INGERSOLL-RAND®

AIR COMPRESSORS

Supplement

Pressure Switches

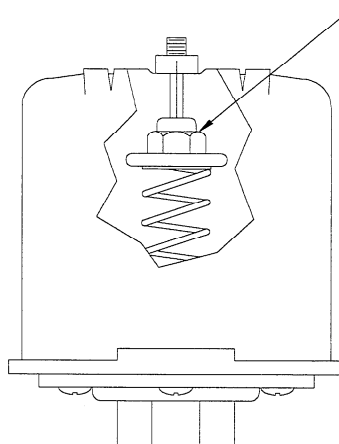
Standard pressure switches provided on Ingersoll-Rand compressor packages are no longer equipped with a differential adjustment control to establish the span between cut-in and cut-out pressure levels. The span is factory set for 40 ± 4 PSIG and cannot be adjusted.

Some pressure switches are equipped with an on-off lever used to open and close the electrical contacts inside the switch. THIS LEVER IS NOT A DIFFERENTIAL ADJUSTMENT CONTROL. The pressure switches with the on-off lever do not have a differential adjustment control.

The range adjustment control is still provided to set the cut-in and cut-out pressure levels.

The pressure switch is equipped with a range adjustment control only. No differential adjustment controls are provided.
